Reference: Heber M. Wells Building Remodel  
DFCM Project No.06187310

Subject: **Addendum No. 1**

# addendum 001

**Job:** Heber Wells  
**Job Number:** 20050373  
**Date:** June 14, 2006

**MH-101-R1-1**

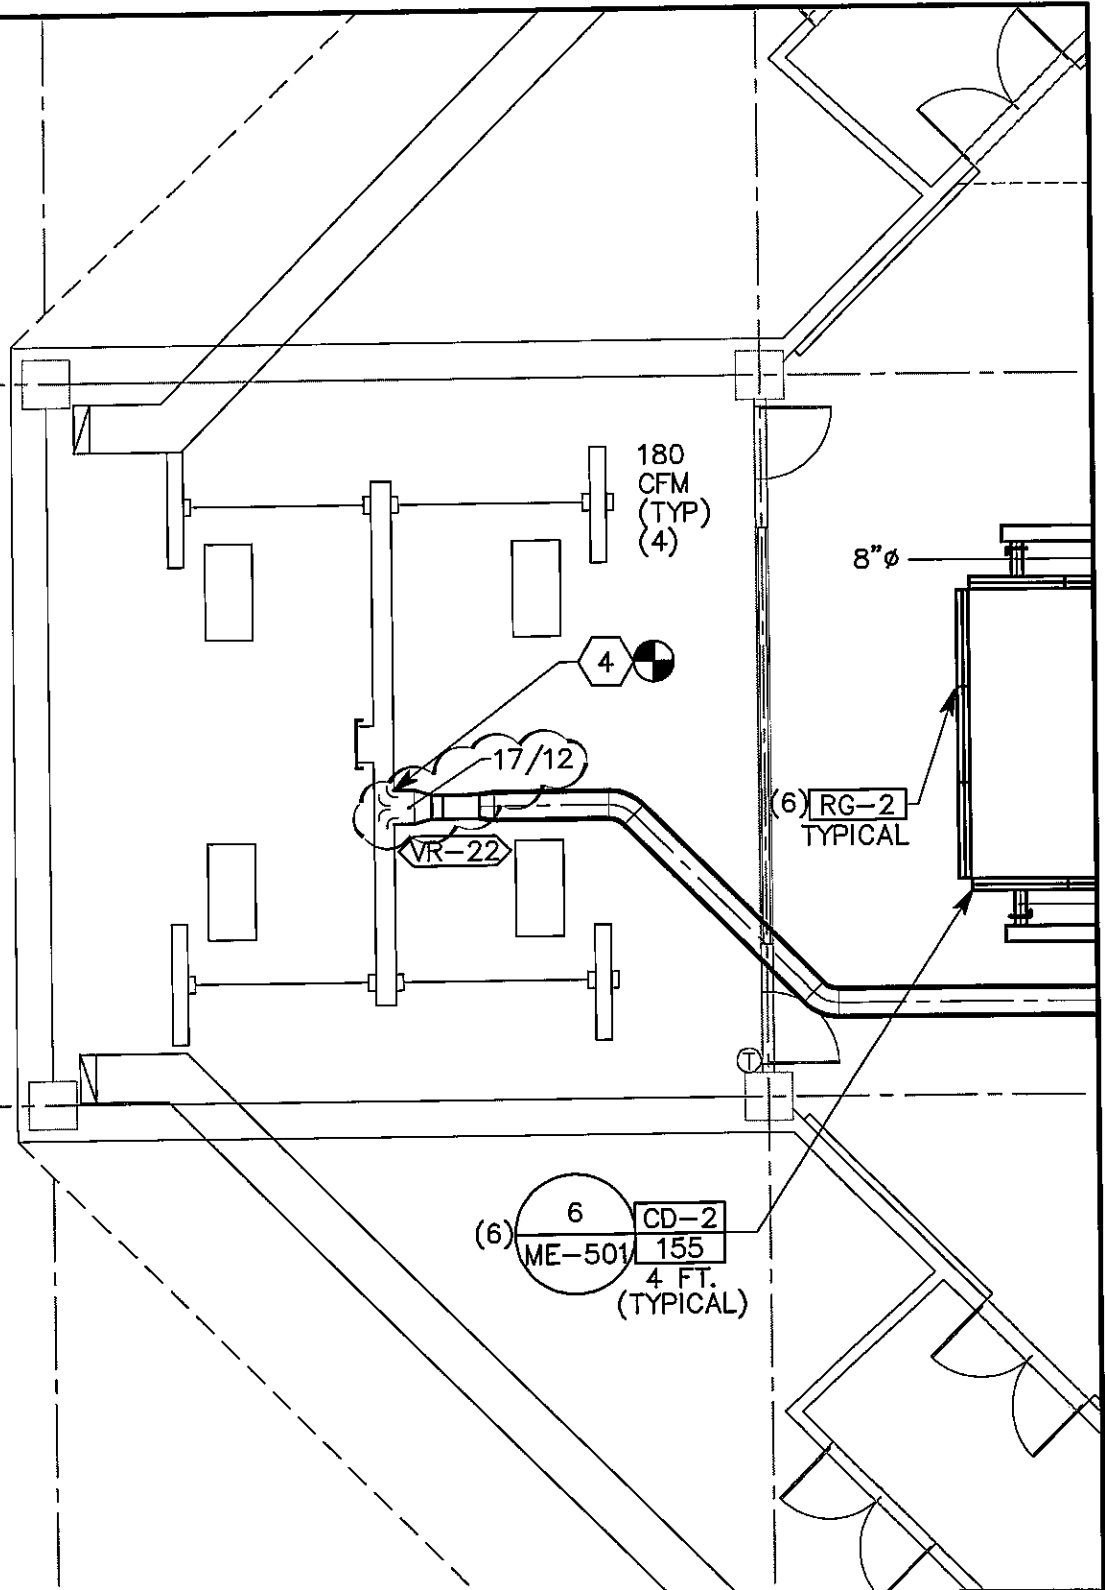
1. Diffusers served by VR-1 should supply 735 cfm each.
2. VR-24 has been added near VR-2 to supply two of the diffusers previously supplied by VR-2.
3. Appropriate duct modifications have been resized. See drawings MH-101-R1-1 and MH-101-R1-2.

**MH-102-R1-1**

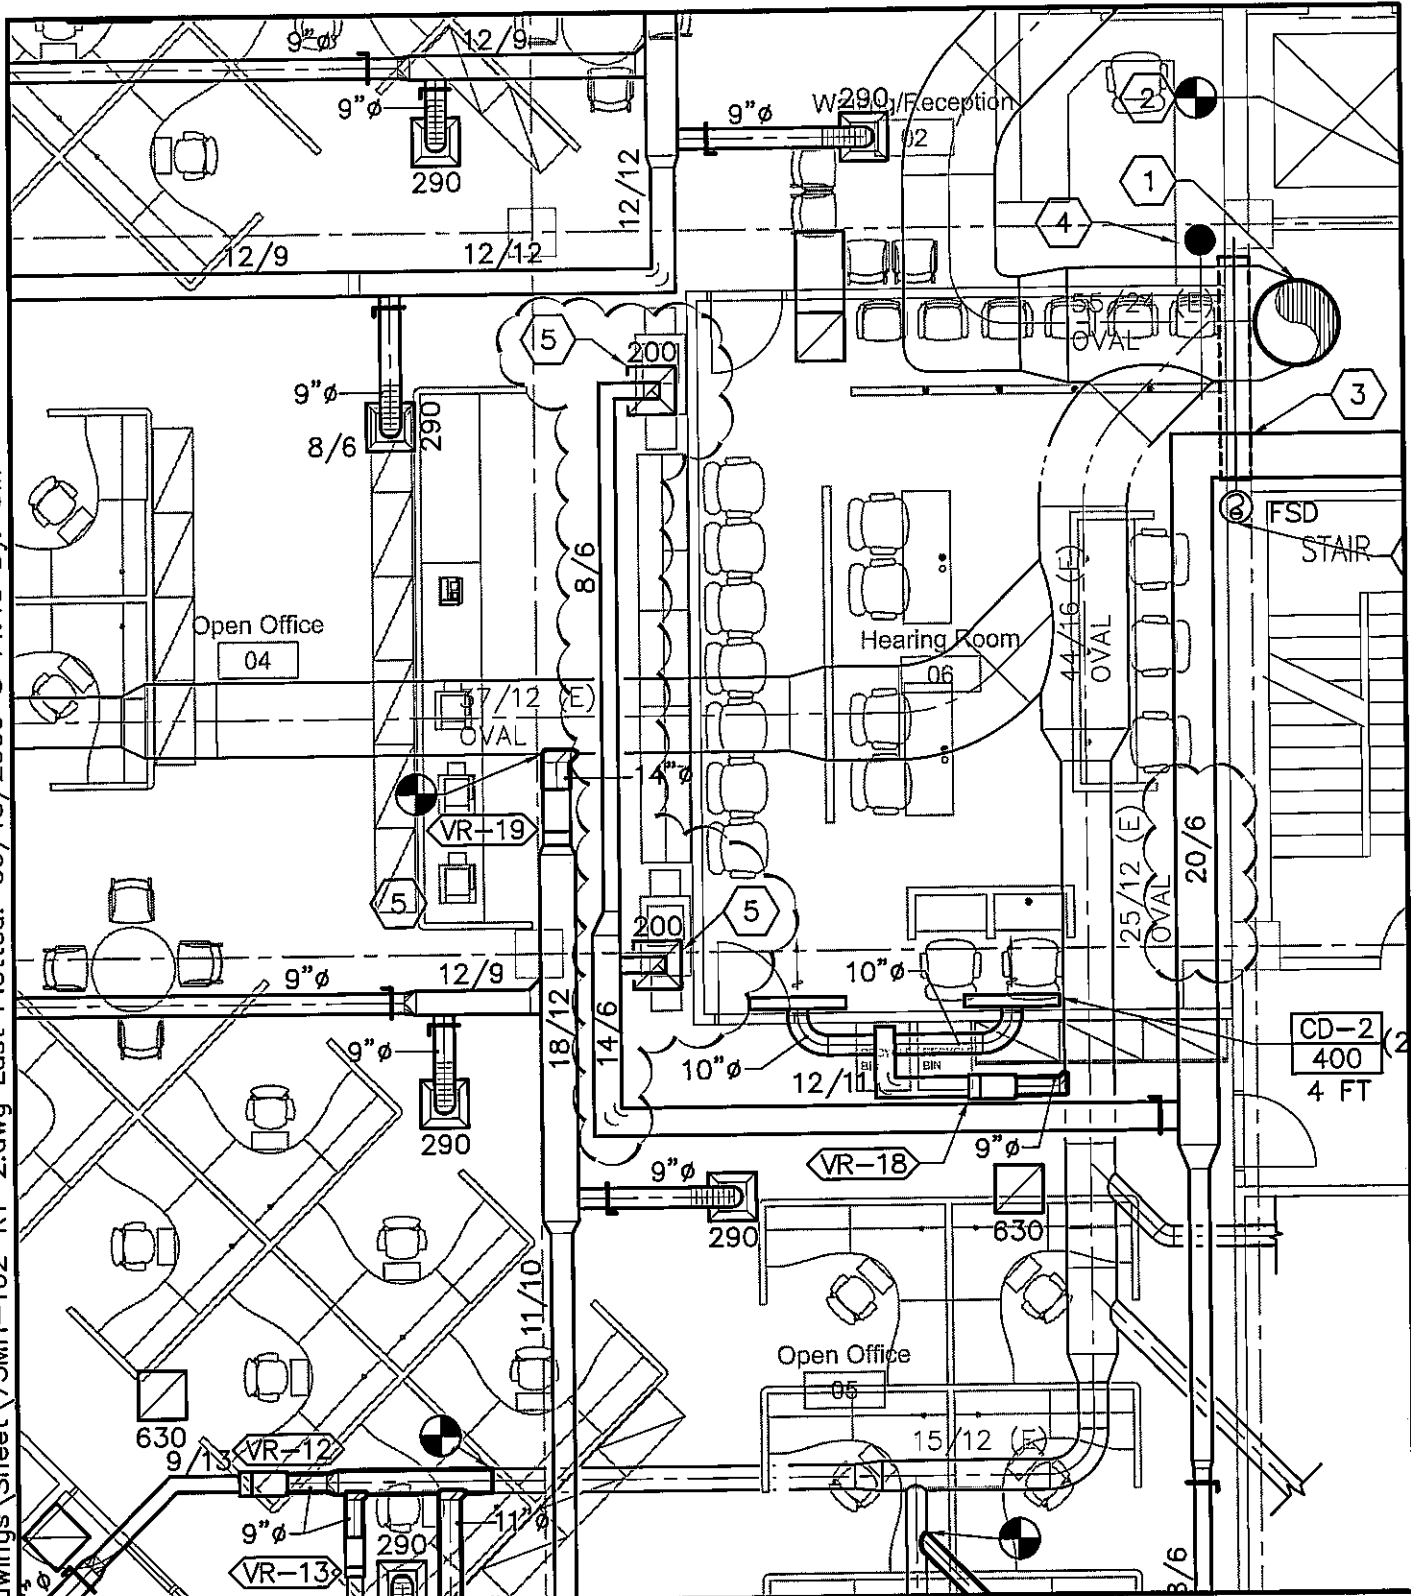
11. Change diffuser supply in Open Office 03, Open Office 04, and Open Office 05 to 250 cfm. Change return air grilles in these areas to 650 cfm.
12. Add supply diffuser in Conference Room 08. See drawing MH-102-R1-1.

13. Add supply diffuser in Break 14. See drawing MH-102-R1-1.
14. Change note number 6 to read "Install new fire/smoke damper in new section of exhaust duct and shaft wall penetration."

**MH-102-R1-2**

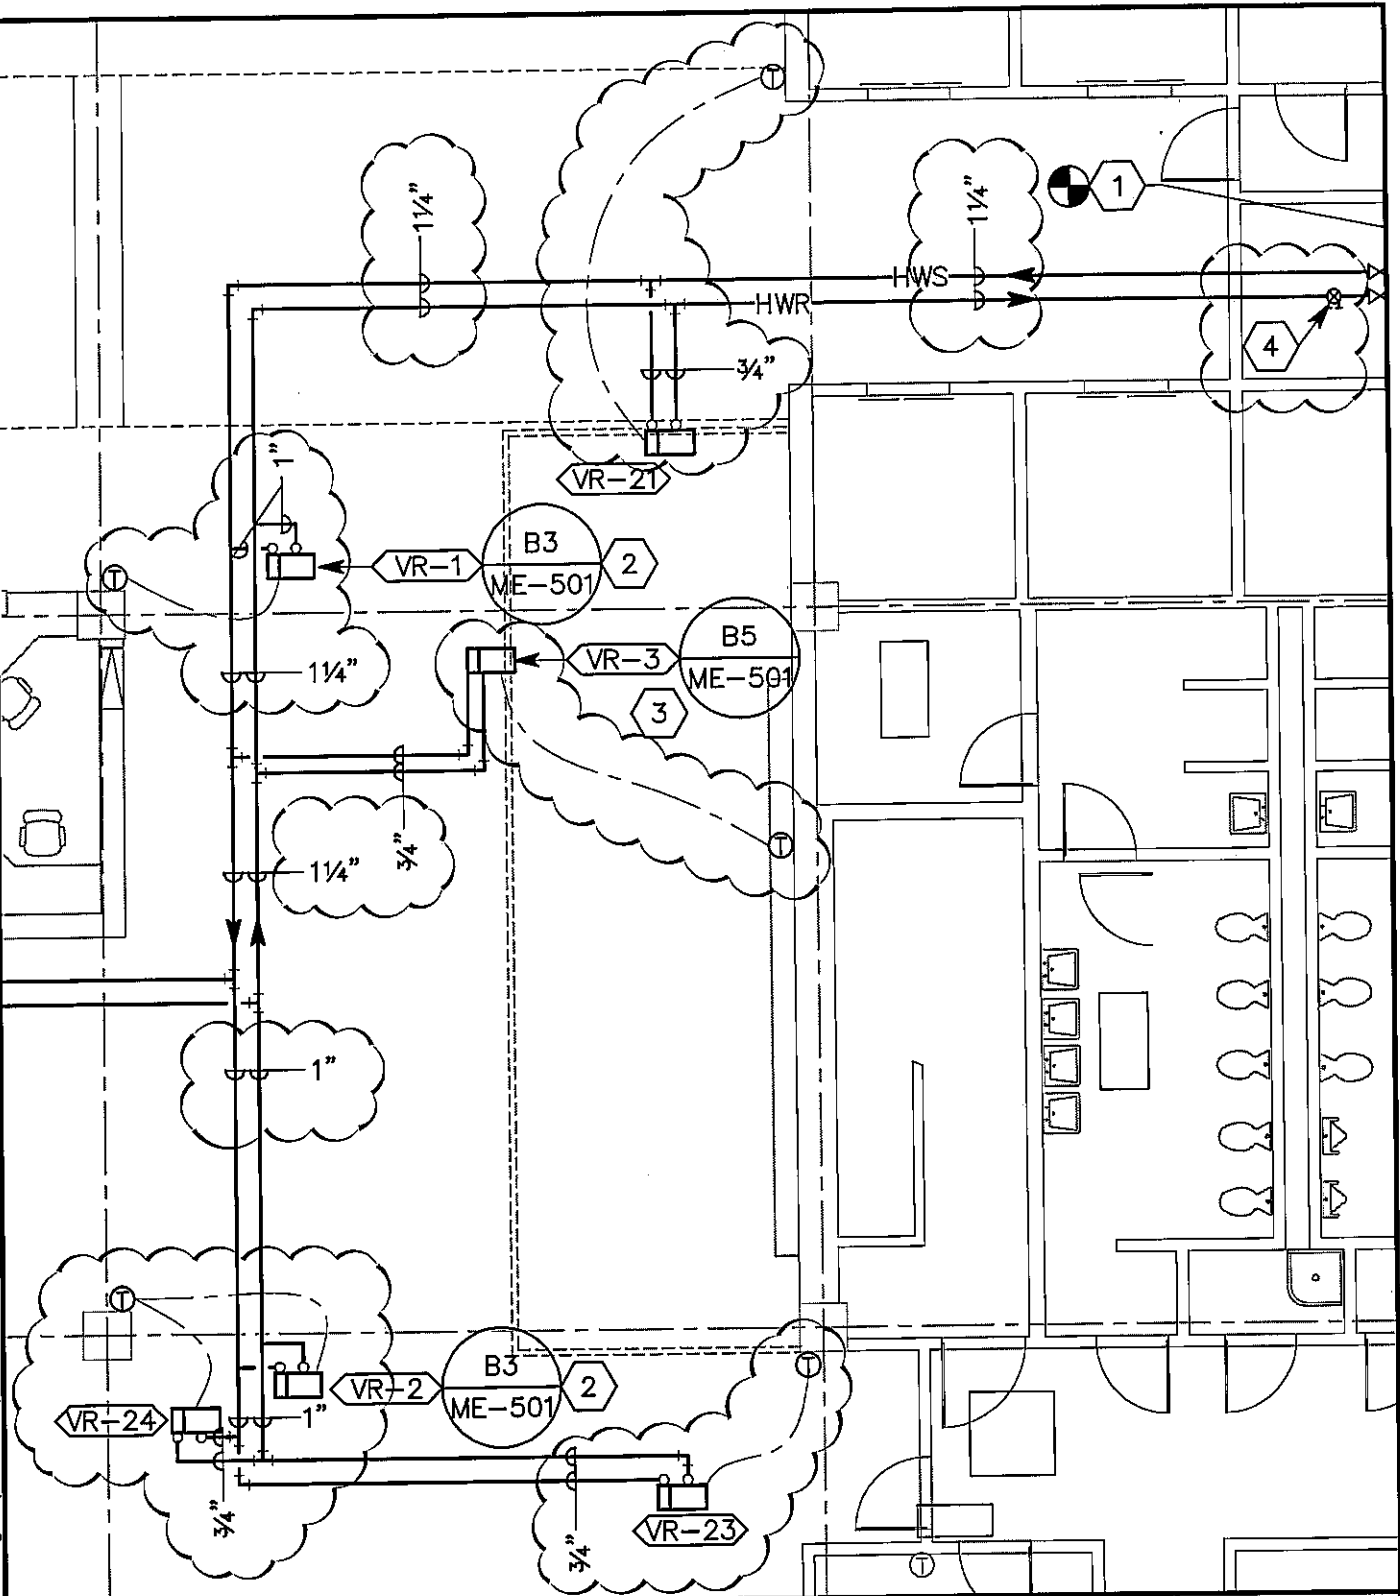
15. Add exhaust grille above new copy machine location, move grille to relocated copy machine. See MH-102-R1-2.

**MP-101-R1-2**

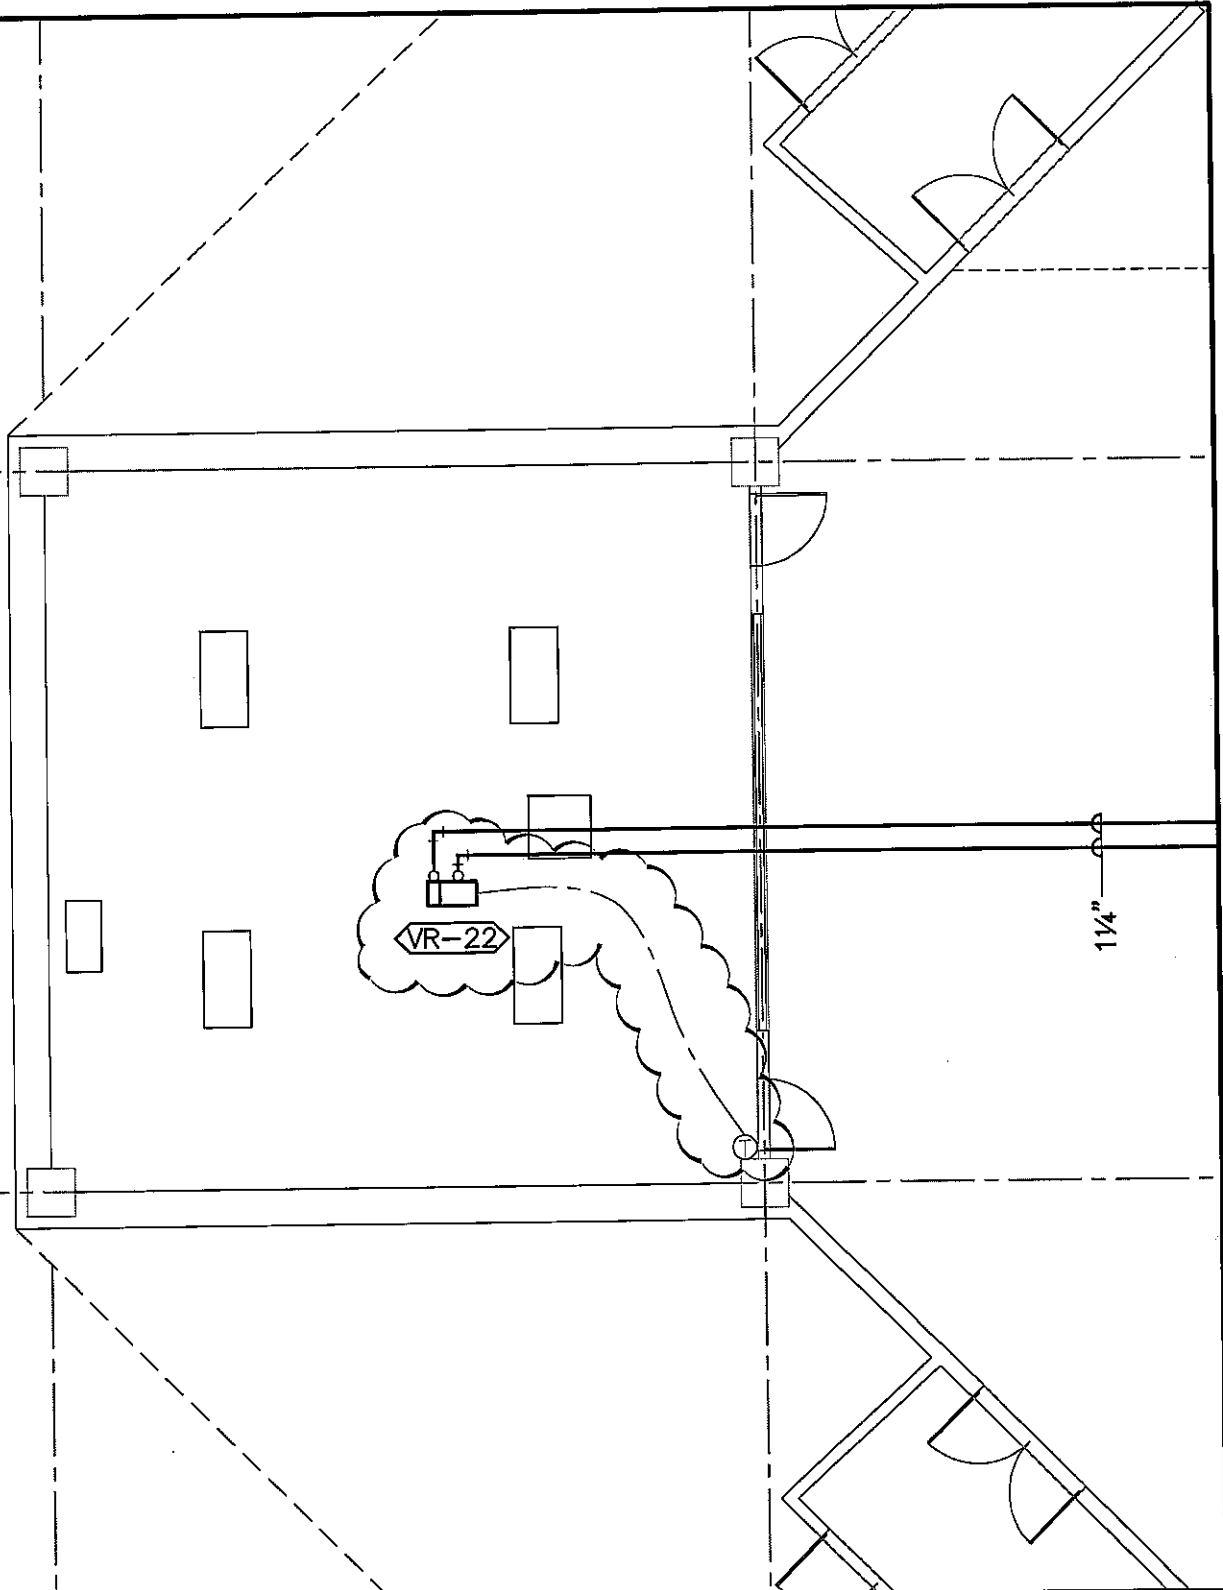
16. VR-24 has been added and shown with corresponding thermostat. See drawing MP-101-R1-1.
17. Thermostats for VAVs have been shown. See drawings MP-101-R1-1 and MP-101-R1-2.
18. Pipe sizes have been shown. See drawings MP-101-R1-1 and MP-101-R1-2.
19. Add note number 4, "Set at 12.8 gpm." See drawing MP-101-R1-3.
